August 25, 2023

Project Name: Madison County Schools - New Tennis Complex

Project Number: 23-034

ADDENDUM NO. 04

Sheet A001 ARCHITECTURAL SITE PLAN

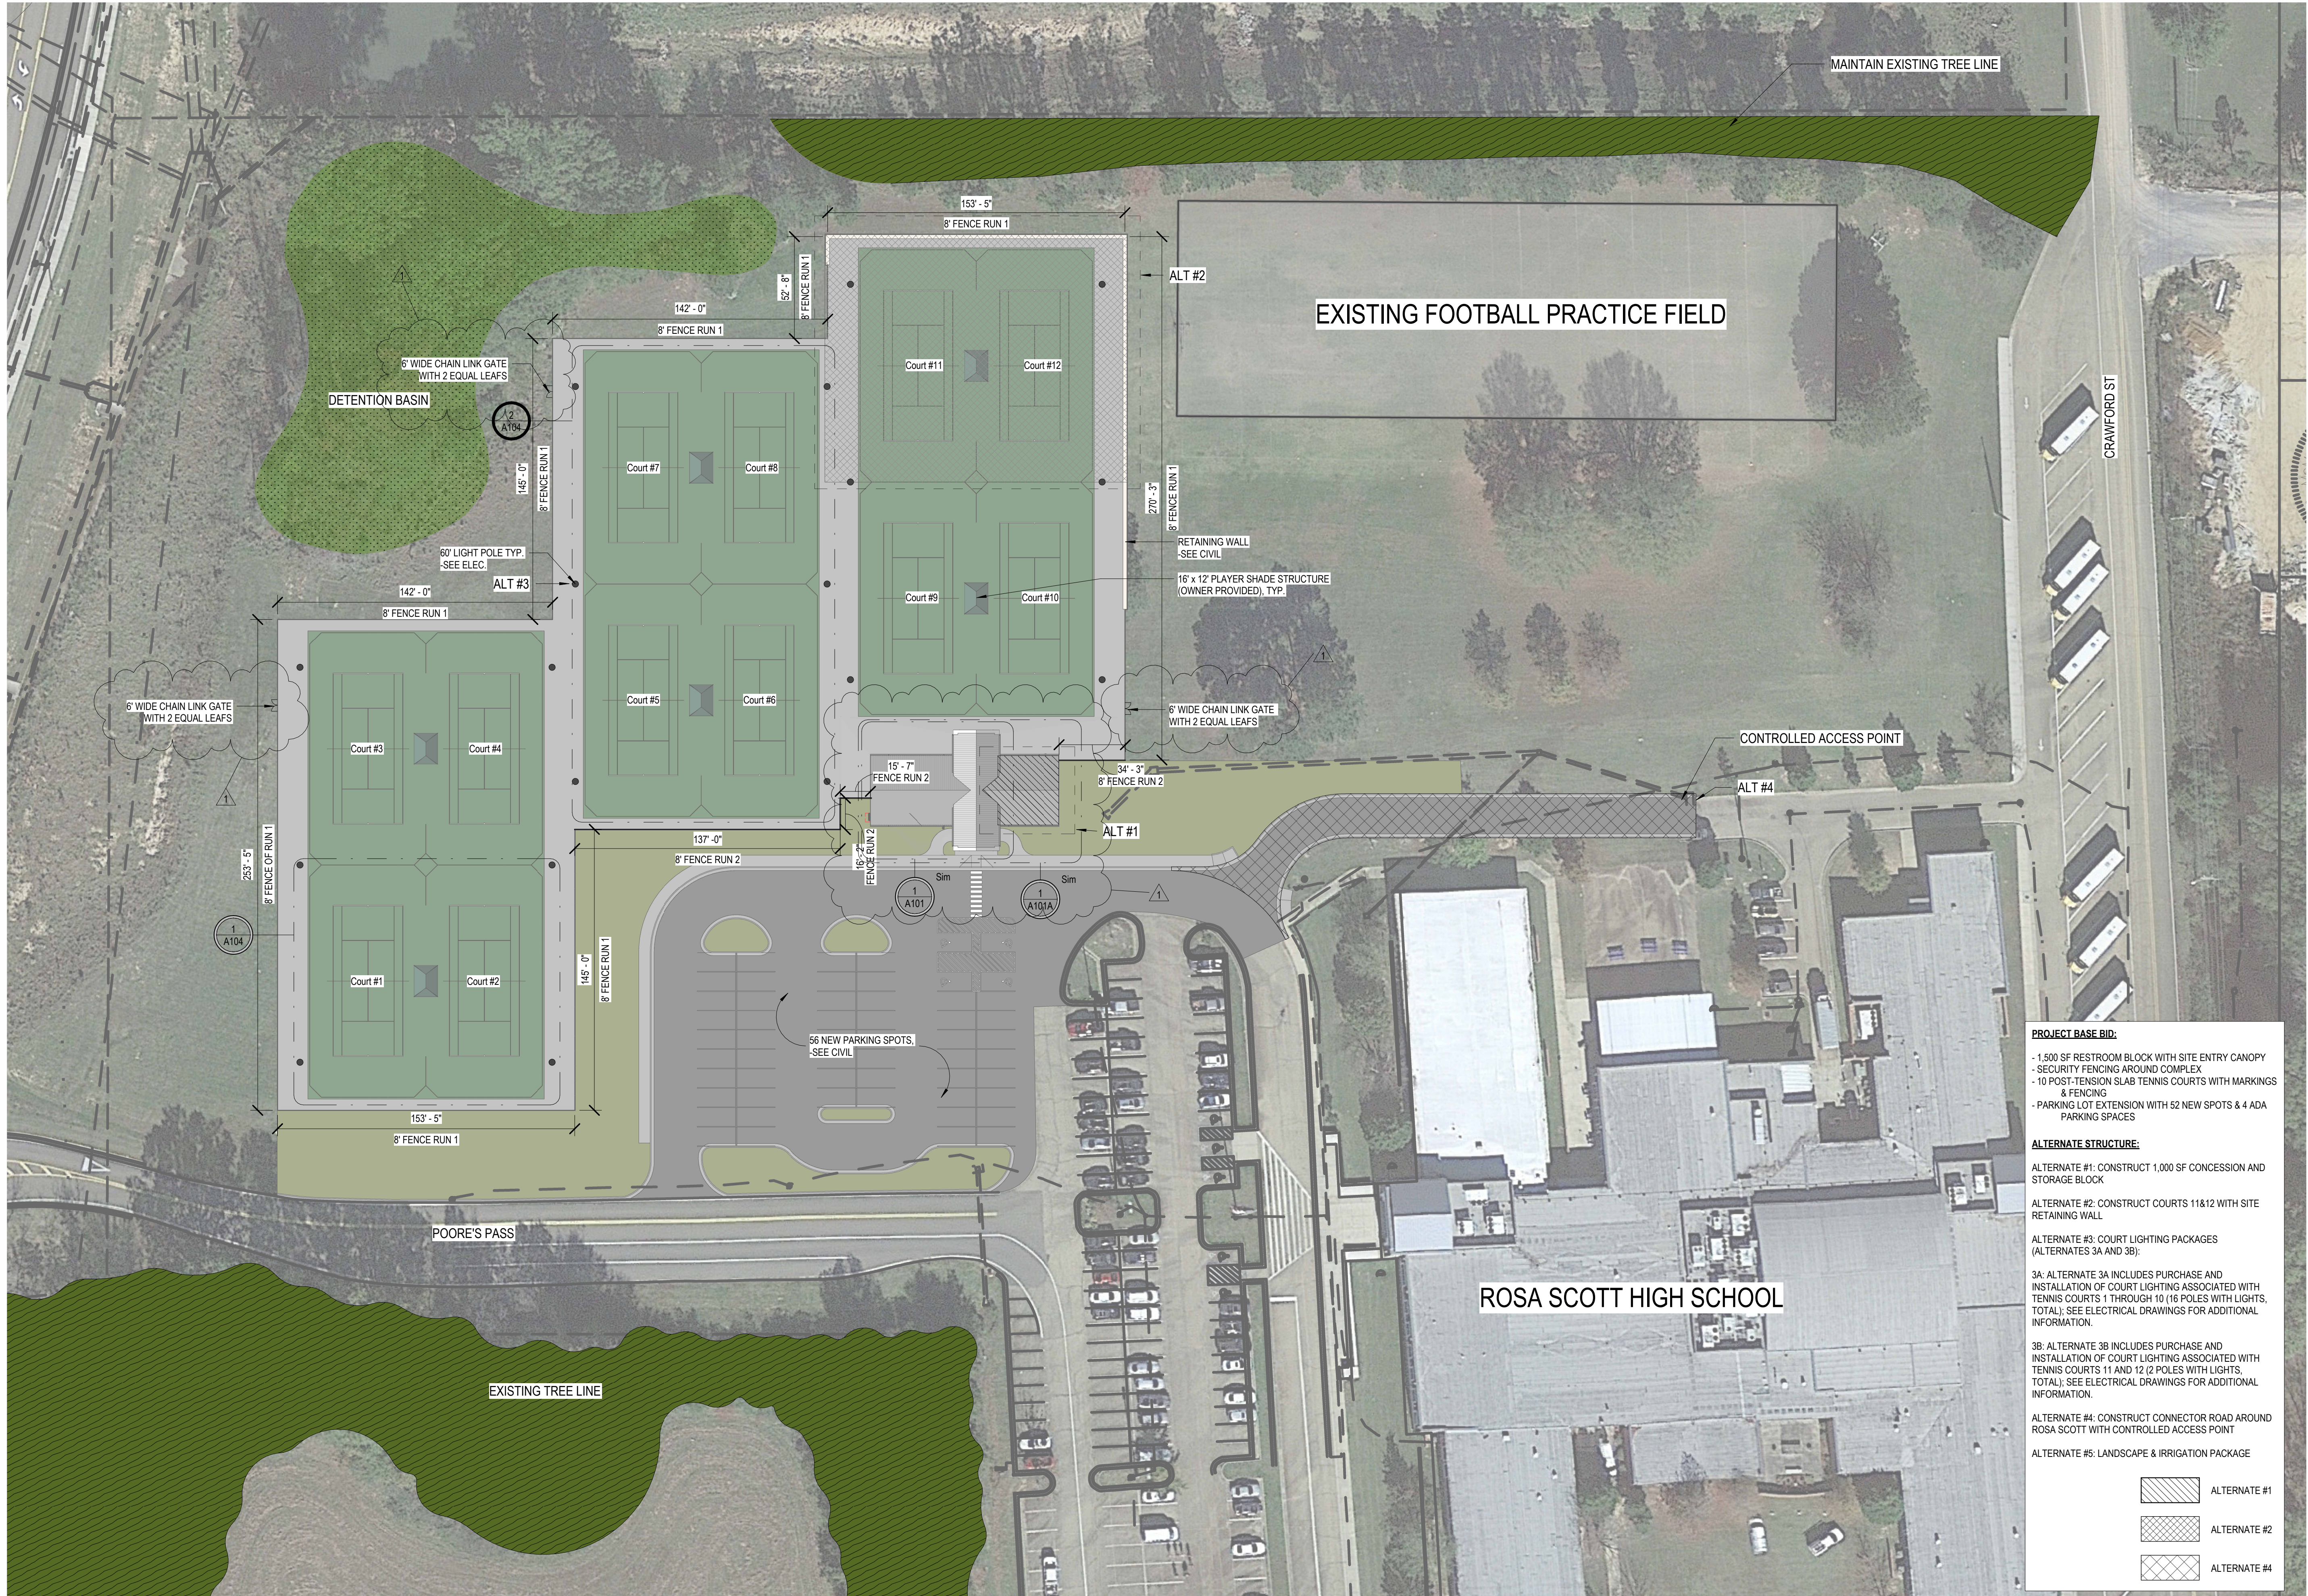
REPLACE sheet **A001**, with the attached **revised A001**.

Clarification: Revisions add callouts for the concessions building plans. Revisions also include the addition of 72” wide passage gates to the perimeter chain link fencing.

A101
FIRST FLOOR PLAN
BASE BID

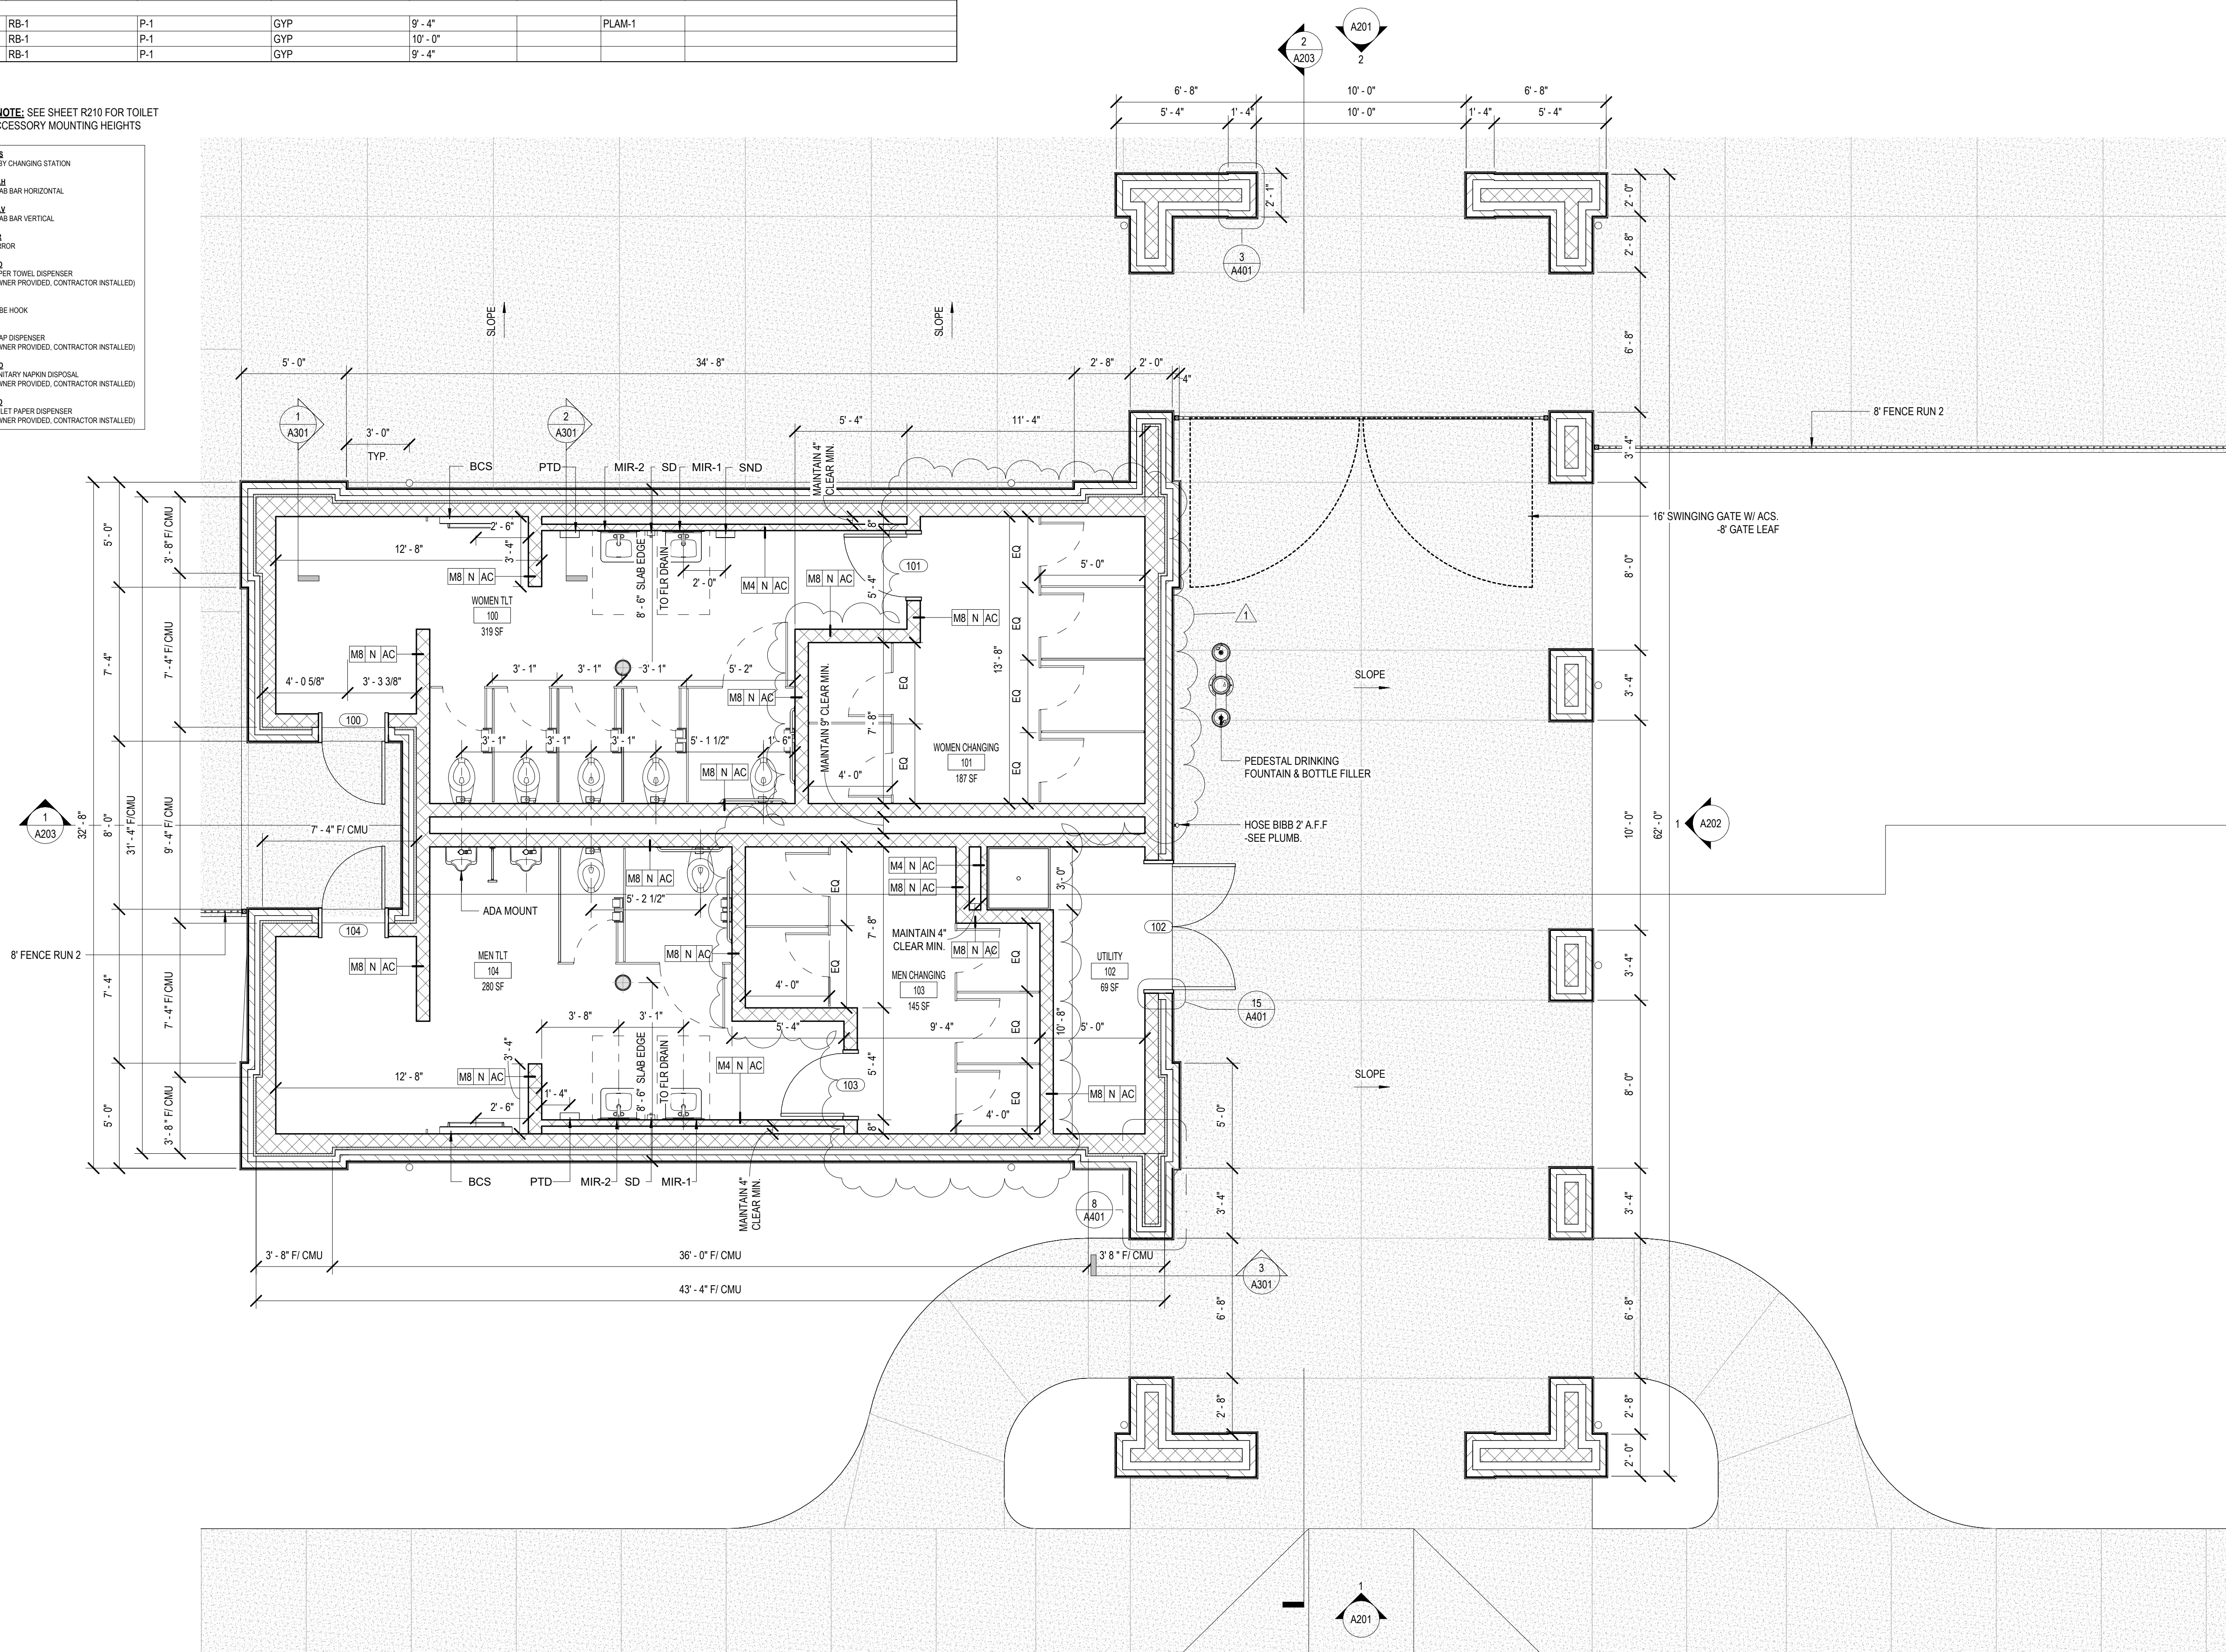
REPLACE sheet **A101**, with the attached **revised A101**.

Clarification: Revised plan adds dimensions to partitions in Women Changing 101 and Men Changing 103.

NOTE: Toilet partitions, urinal dividers, and changing room partitions shall all meet the requirements of Specification Section 10.2113.19 - Plastic Toilet Compartments.

1 ELECTRICAL SITE PLAN
E101 SCALE: 1" = 30'-0"

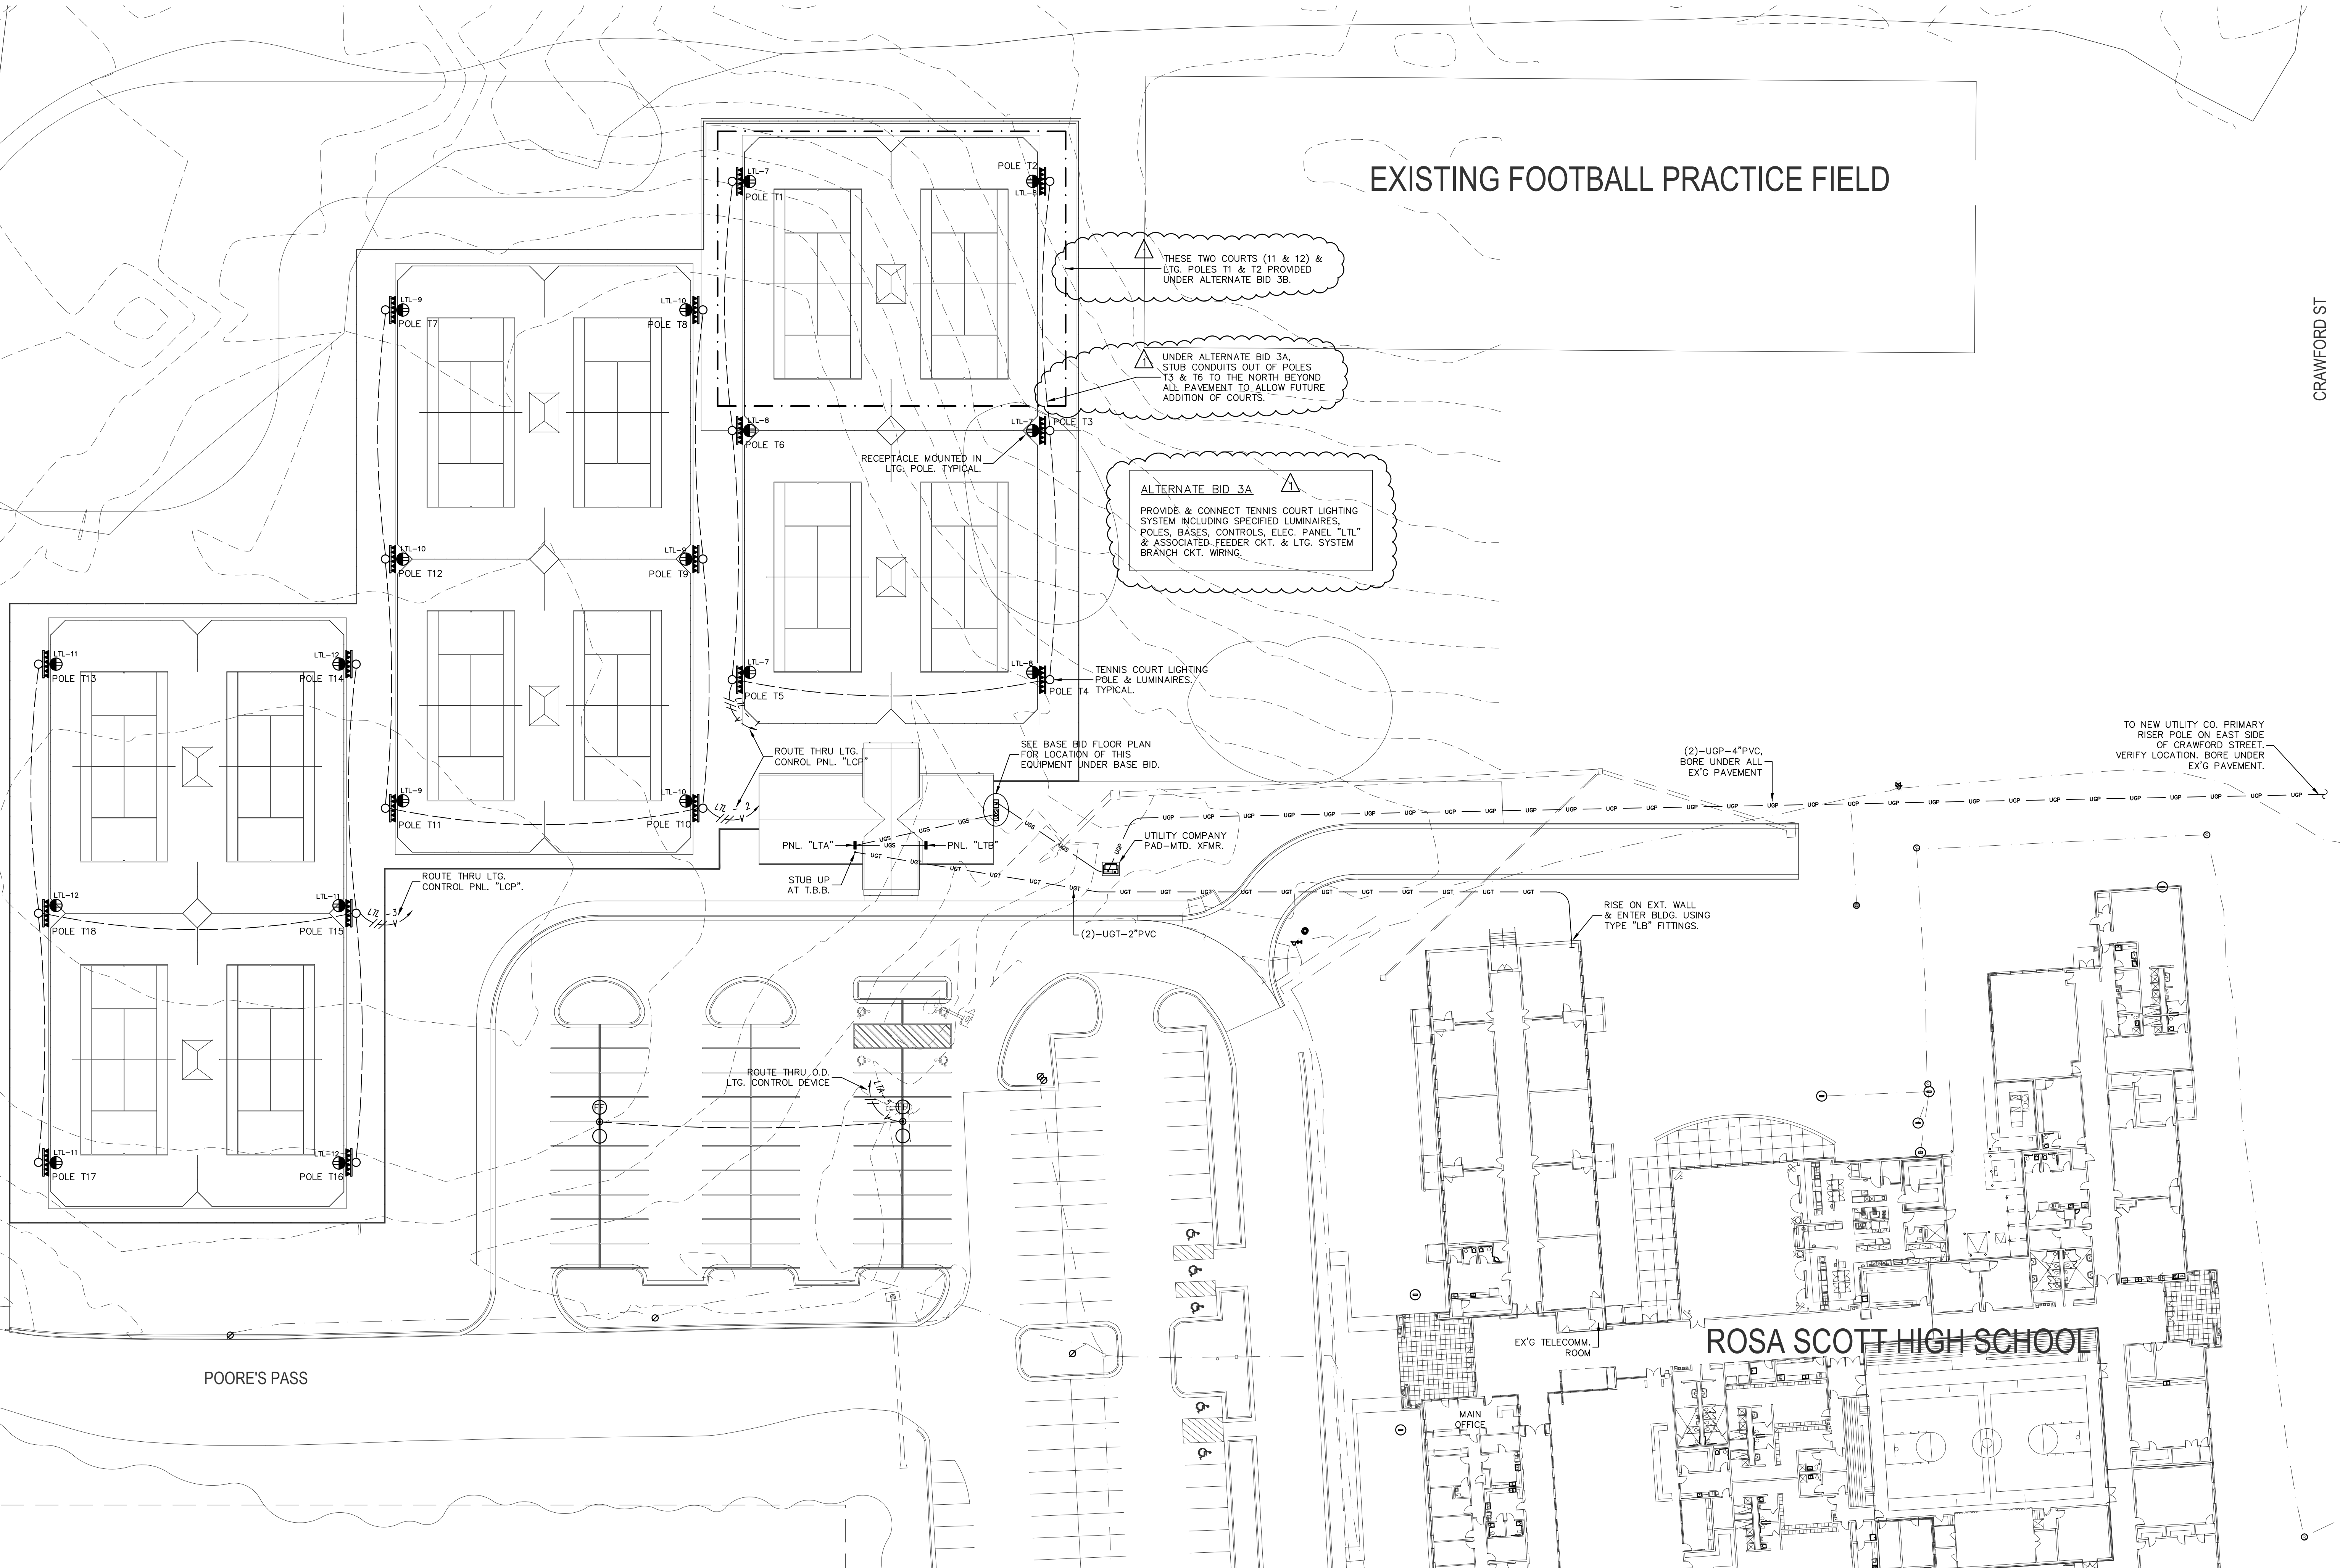
REPLACE sheet **E101**, with the attached **revised E101**.

Clarification: Revised drawing indicates poles and luminaires to be included in Alternates 3A or 3B.
